SUBJECT: Forwards revised FSAR figures documenting analyses of SER
 Confirmatory Issue 1 re final pipe break locations & design
 of pipe whip restraints. Final break locations based on
 completion of as-built programs & final stress analysis.

August 8, 1983
G02-83-705

Subject: NUCLEAR PROJECT NO. 2
SAFETY EVALUATION REPORT, CONFIRMATORY
ISSUE (1) BREAK LOCATIONS

The subject confirmatory issue requires submittal of the results of analyses to determine final pipe break locations and final design of pipe whip restraints. Attached are the revised FSAR figures documenting these analyses. It should be noted that these revisions indicate break locations based on the "status as built" stress analysis with thermal and fatigue loads. The "status as built" is not a final "as built" configuration; however, the Supply System does not anticipate any significant differences. Hence, the stress analysis and resulting pipe break locations in the attached figures, although not based on a final "as built", will not differ significantly from the final break locations. The final break locations will be based on completion of the "as built" program and the final stress analysis. Although no changes ar

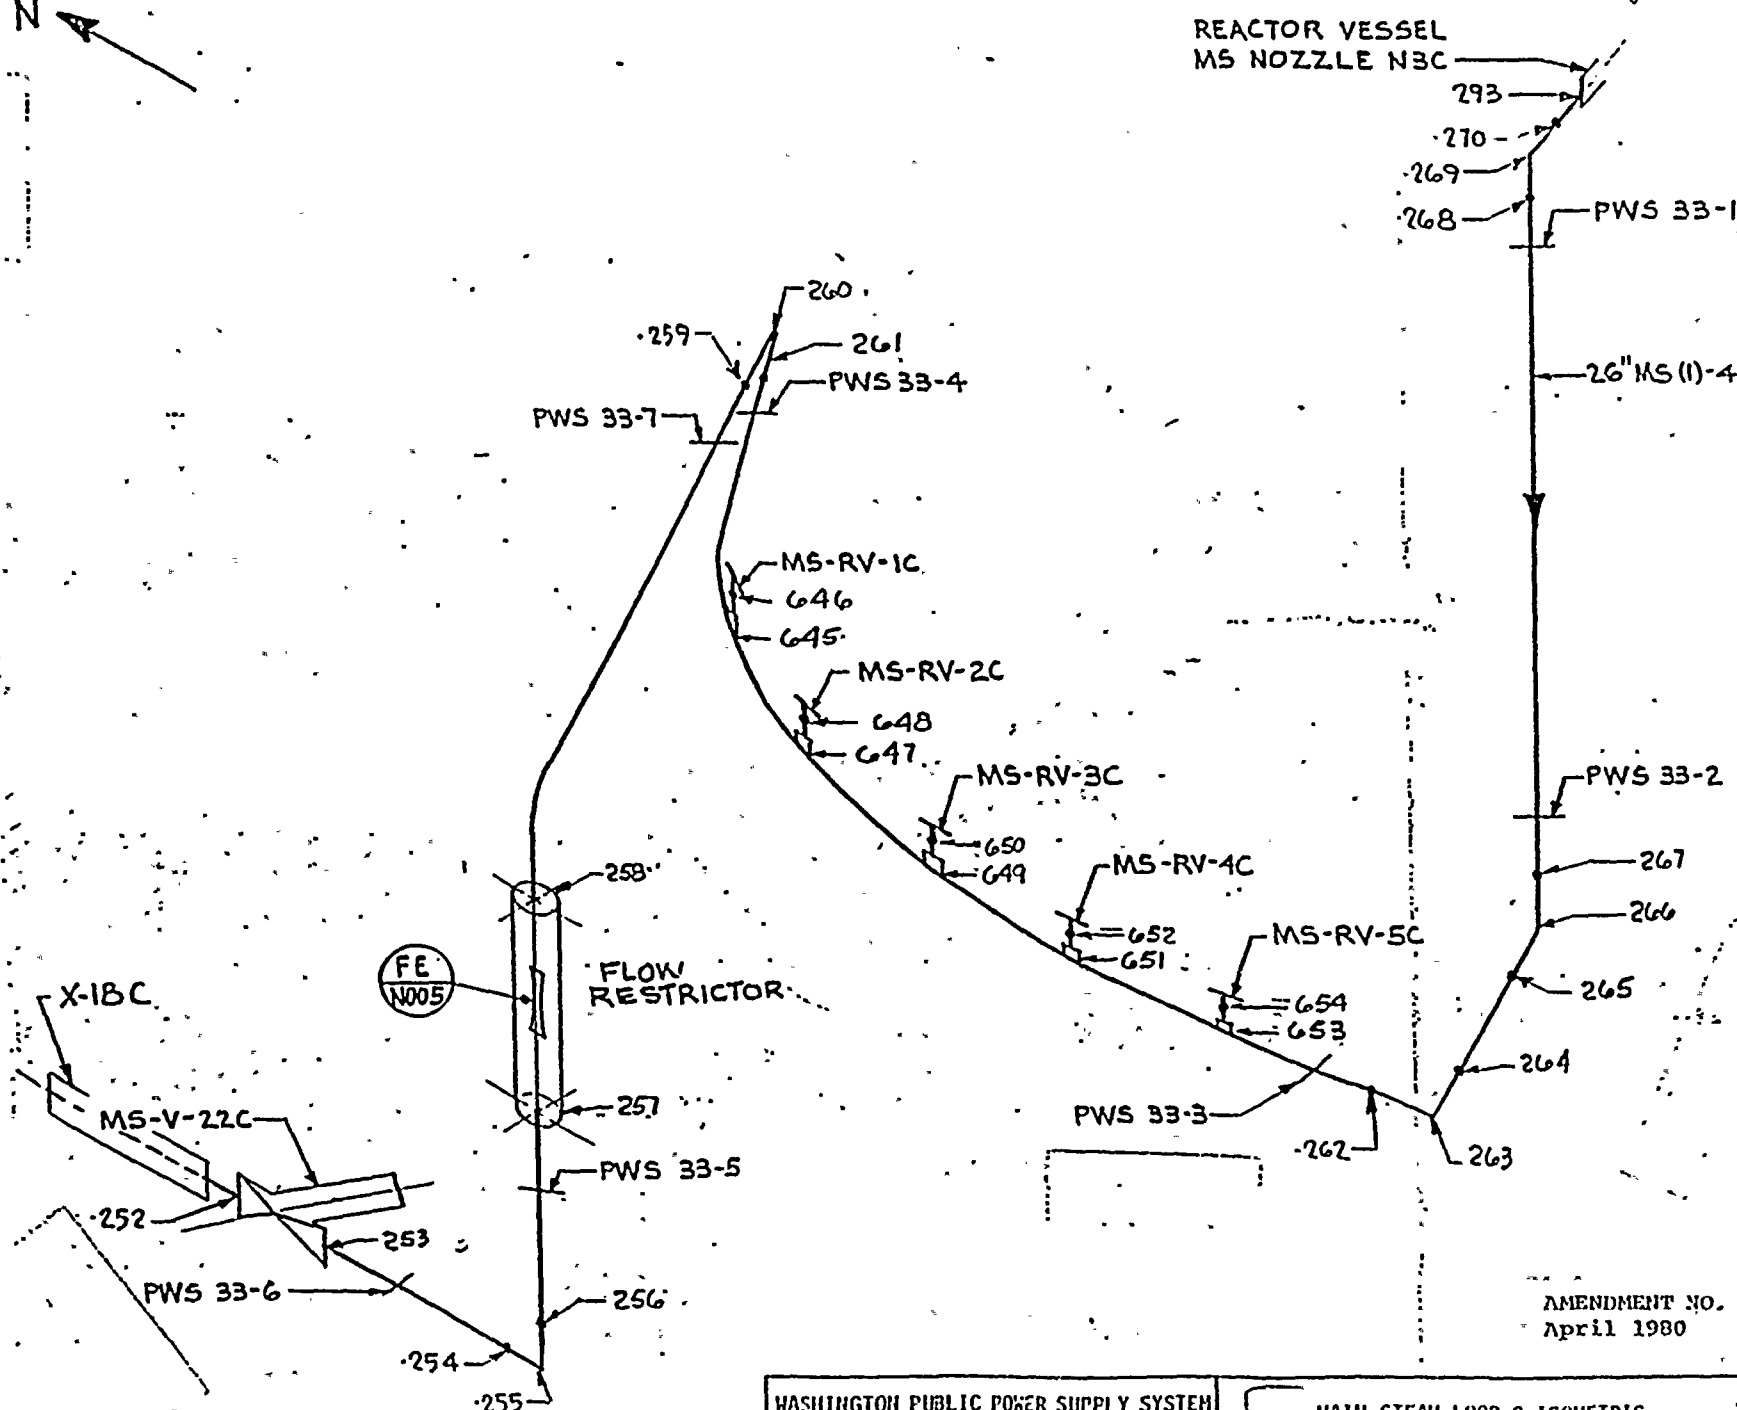
CIRCUMFERENTIAL BREAKS

~~Node 233~~
~~Node 234~~
Node 235
Node 237
~~Node 238~~
~~Node 239~~
Node 240
Node 242
~~Node 243~~
~~Node 245~~
Node 246
Node 248
Node 249
Node 251
Node 292
Node 636
~~Node 638~~
Node 640
~~Node 642~~
Node 644
NODE 214A
~~NODE 643~~
~~NODE 644~~
~~NODE 639~~
~~NODE 637~~
~~NODE 635~~

LONGITUDINAL BREAKS

Node 236
Node 241
~~Node 244~~
Node 247
Node 250
NODE 643
NODE 641
NODE 639
NODE 637
NODE 635

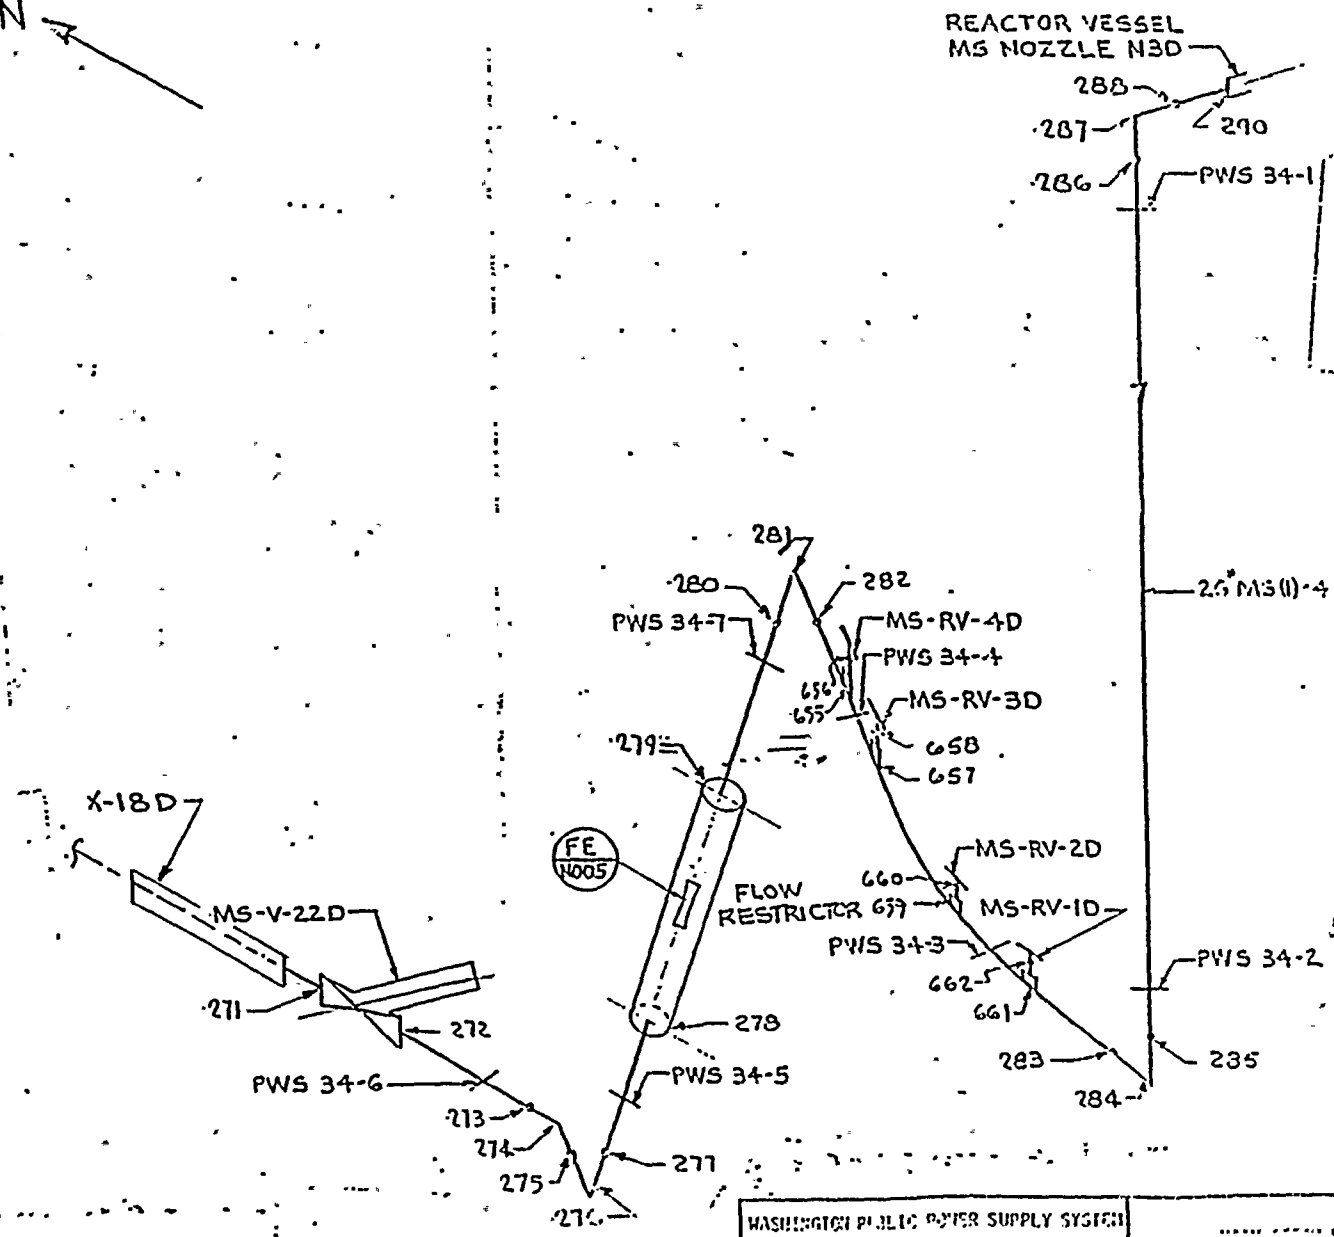
SUMMARY OF POSTULATED PIPE BREAK LOCATIONSCIRCUMFERENTIAL BREAKS

~~Node 252~~
~~Node 253~~
Node 254'
Node 256'
~~Node 257~~
~~Node 258~~
Node 259.
Node 261.
~~Node 262~~
~~Node 264~~
Node 265.
Node 267.
Node 268.
Node 270.
Node 293.
Node 646' *NODE 646'*
~~Node 648~~
Node 650' *NODE 650'*
~~Node 652~~
Node 654'

LONGITUDINAL BREAKS

Node 255-
Node 260-
~~Node 263~~
Node 266 -
Node 269 -
NODE 653 -
NODE 651 -
NODE 649 -
NODE 647 -
NODE 645 -

WASHINGTON PUBLIC POWER SUPPLY SYSTEM NUCLEAR PROJECT NO. 2	REACTOR FEEDWATER (LINE A)	Figure 3.6-16 b
---	----------------------------	--------------------

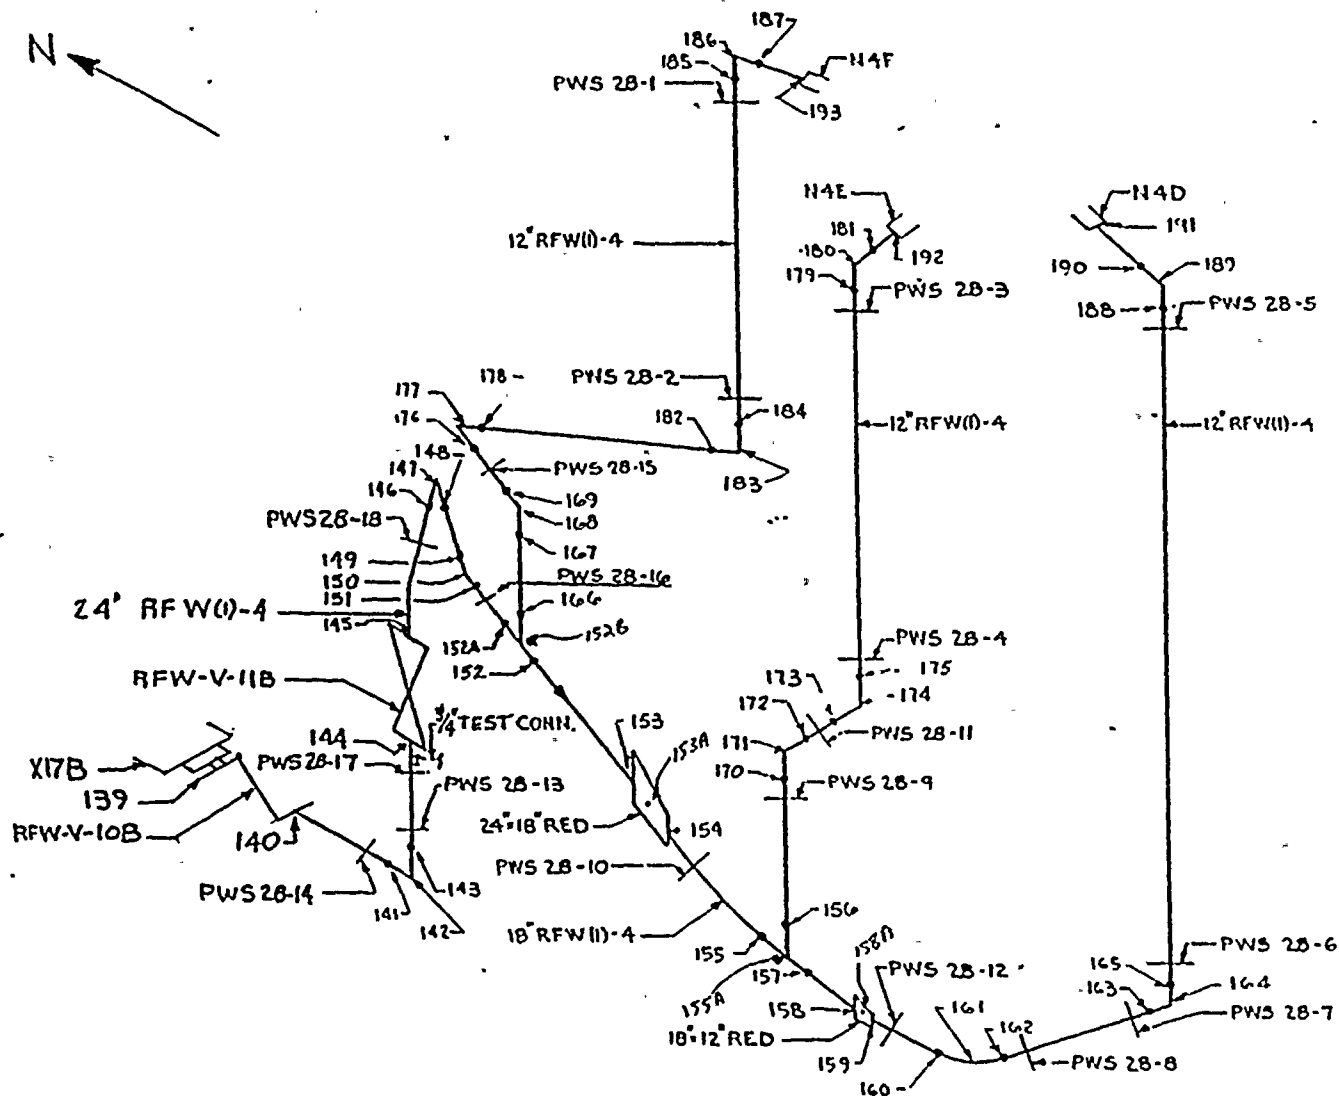
SUMMARY OF POSTULATED PIPE BREAK LOCATIONS

CIRCUMFERENTIAL BREAKS

NODE		
85	124	115
86	126	117
88	127	118
89	129	120
90	136	130
91	100	132
93	101	137
97A	102	103
97	104	
111	105	
98	107	
99	108	
112	110	
114	133	
121	135	
123	138

LONGITUDINAL BREAKS

NODE	
87	97B
92	98A
113	100A
122	103A
125	
128	
106	
109	
134	
116	
119	
131

Note: Break locations based on change in piping flexibility because stress analysis not complete.

FIGURE
3.6-17b

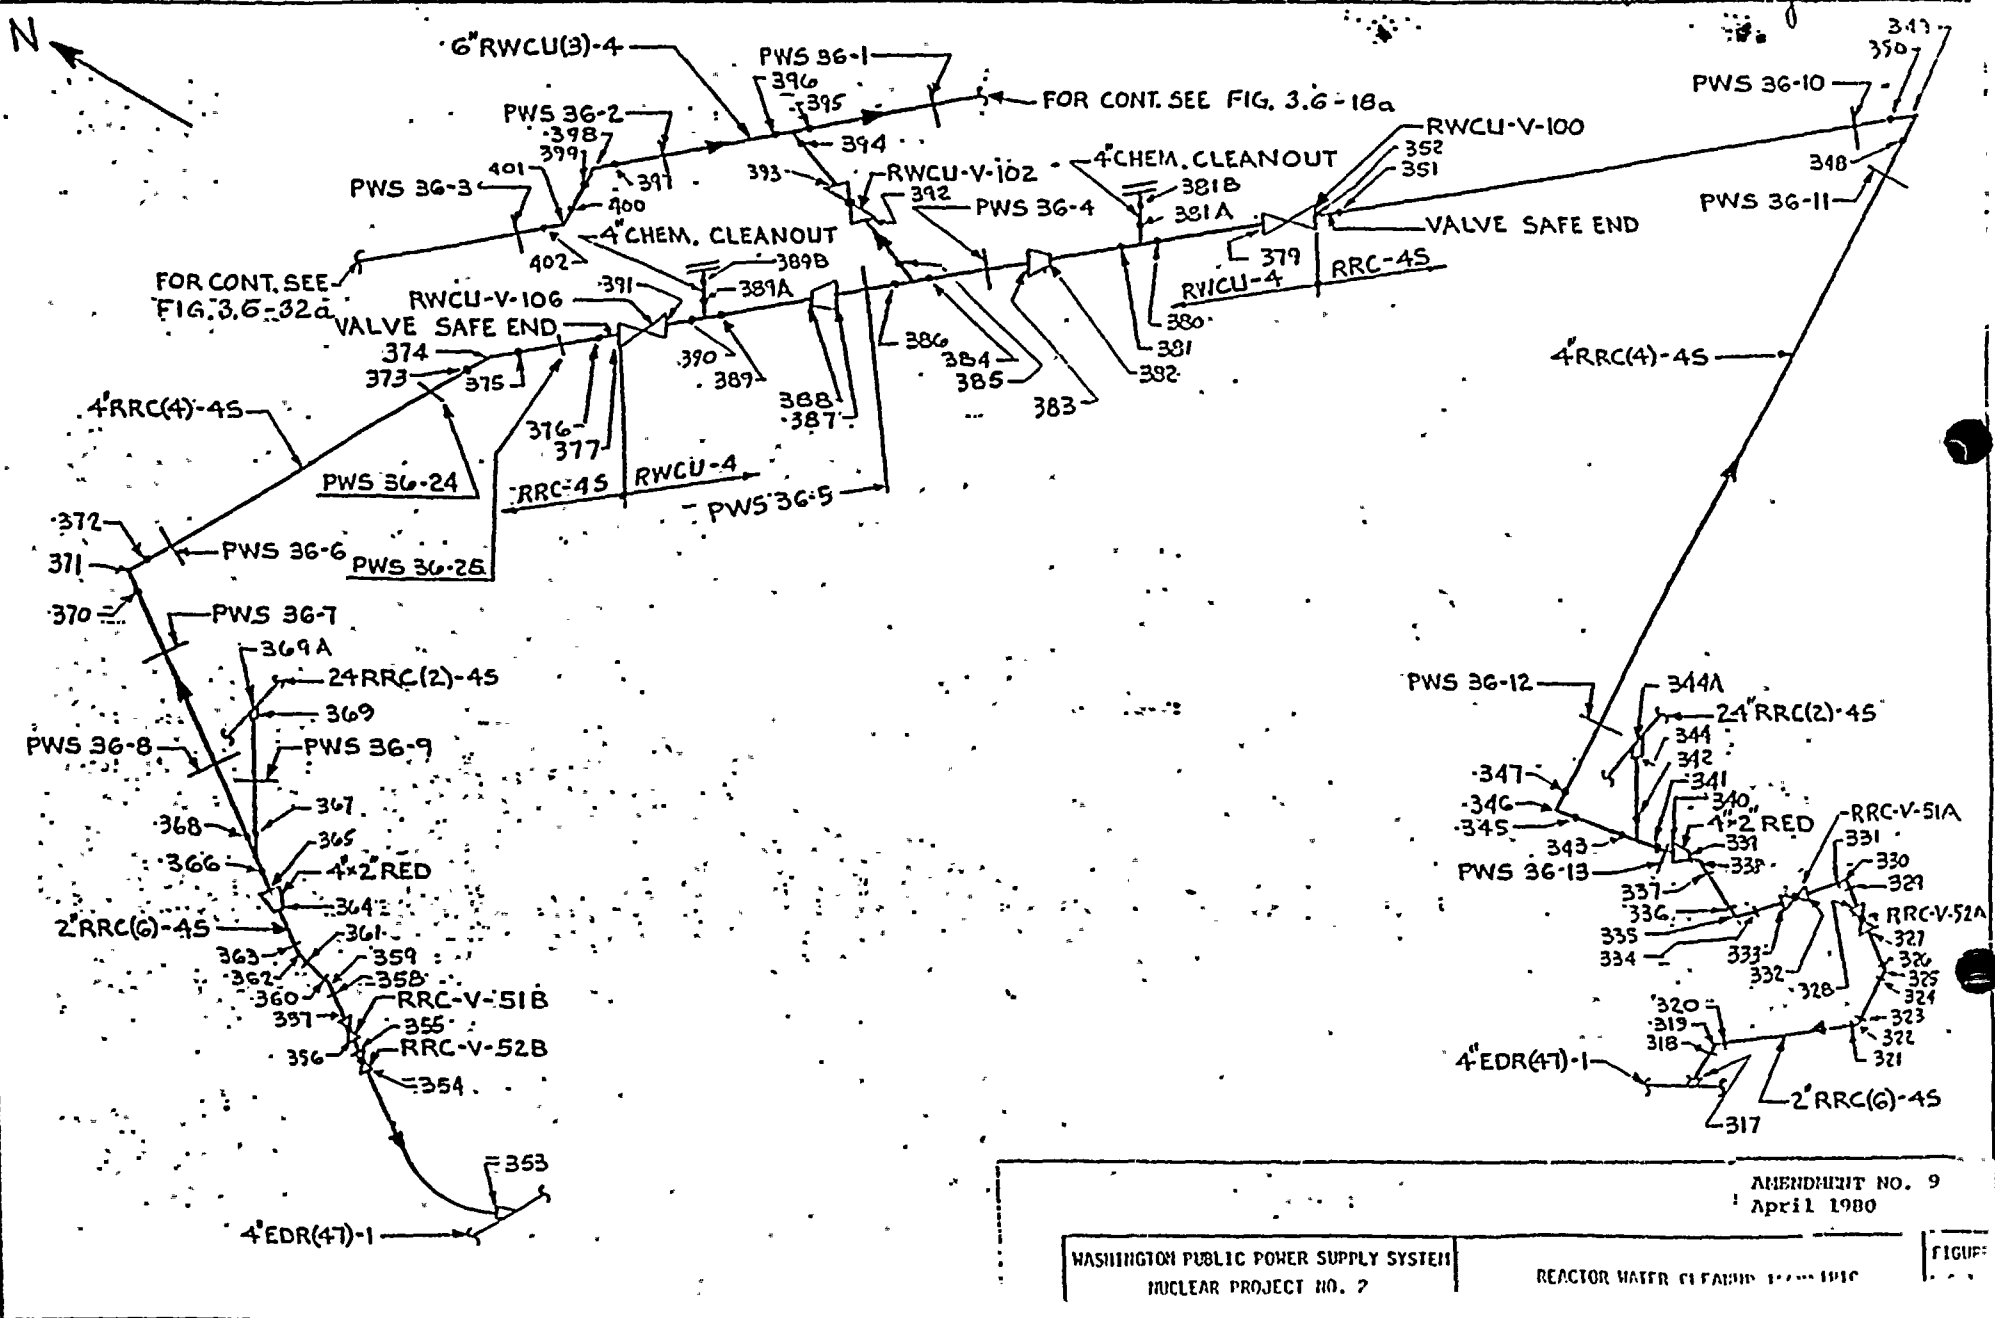
SUMMARY OF POSTULATED PIPE BREAK LOCATIONS

CIRCUMFERENTIAL BREAK

LONGITUDINAL BREAK

NODE	
140	154
141	155
143	156
144	157
145	170
146	172
148	173
152 A	175
152	179
166	181
167	192
169	159
176	160
178	162
182	163
184	165
185	188
187	190
193	191
153	158

NODE	
142	152 B
147	153 A
168	155 A
177	158 A
183	
186	
171	
174	
180	
161	
164	
189

Note: Break locations based on change in piping flexibility because stress analysis not complete.

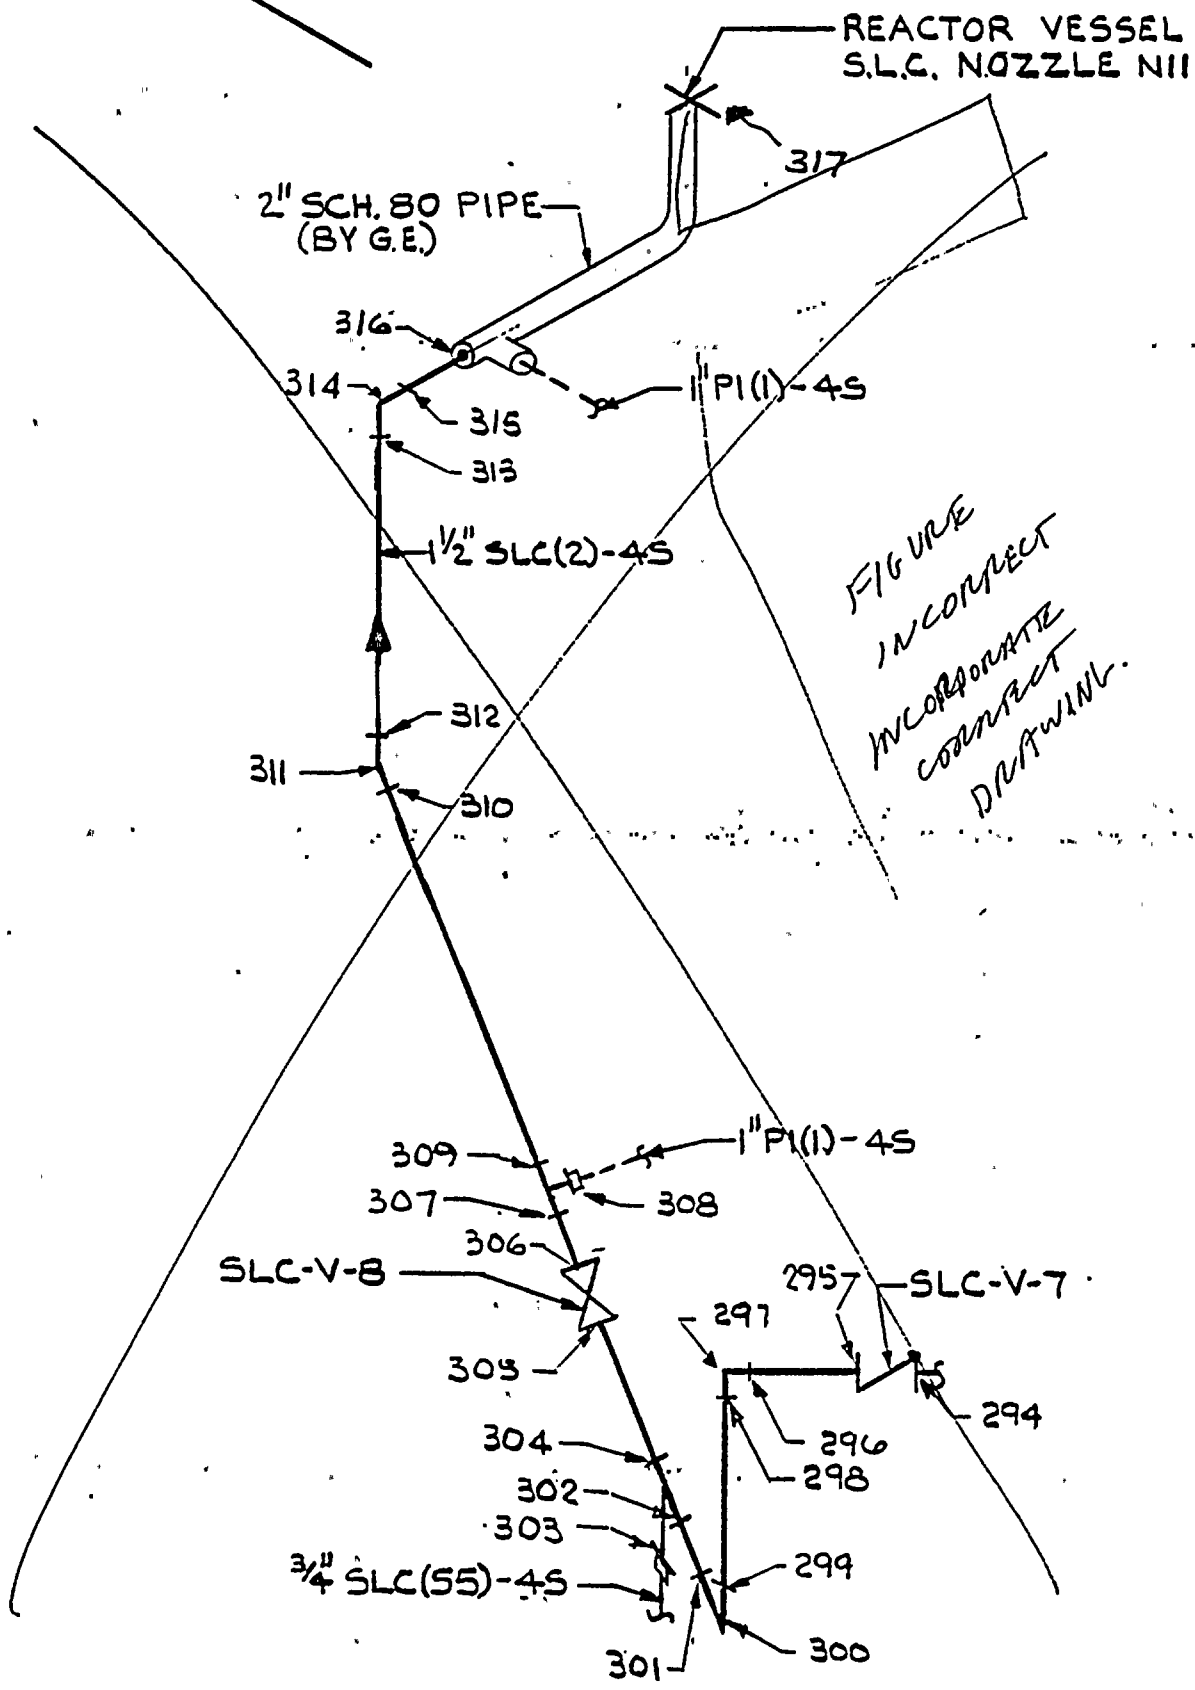
SUMMARY OF POSTULATED PIPE BREAK LOCATIONSCIRCUMFERENTIAL BREAKSNODE 333

~~Node 340~~
~~Node 341~~
~~Node 342~~
~~Node 343~~
Node 344
~~Node 345~~
~~Node 347~~
~~Node 348~~
~~Node 350~~
~~Node 352~~
~~Node 365~~
Node 366
Node 367
Node 368
~~Node 369~~
~~Node 370~~

NODE 357

~~Node 372~~
Node 373
~~Node 375~~
~~Node 377~~
Node 379
~~Node 380~~
Node 381
~~Node 381A~~
~~Node 381B~~
~~Node 382~~
~~Node 383~~
~~Node 384~~
Node 385
~~Node 386~~
~~Node 387~~

~~Node 388~~
~~Node 389~~
~~Node 389A~~
~~Node 389B~~
~~Node 390~~
Node 391
~~Node 392~~
~~Node 393~~
Node 394
Node 395
Node 396
~~Node 397~~
~~Node 399~~
~~Node 400~~
~~Node 402~~

LONGITUDINAL BREAKS

~~Node center of [341, 342, 343] (TEE)~~

~~346~~
~~349~~

~~Node center of [384, 385, 386] (TEE)~~

~~374~~
~~371~~
